CITY OF PLANTATION DEVELOPMENT REVIEW APPLICATION

8601 W. Sunrise Boulevard Conditional Use

**Planning, Zoning & Economic Development I
Memorandum**

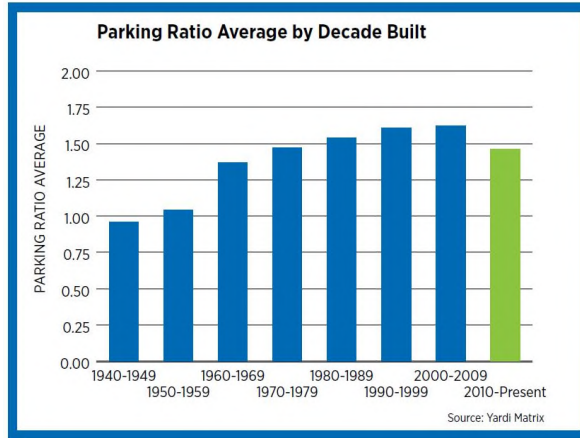
1. **From:** Section 27-641 which states that minimum setbacks need to be 1.5 times the height of the building.

To: Our dimensions vary throughout the project as detailed on page A2.1 of the submittal package.
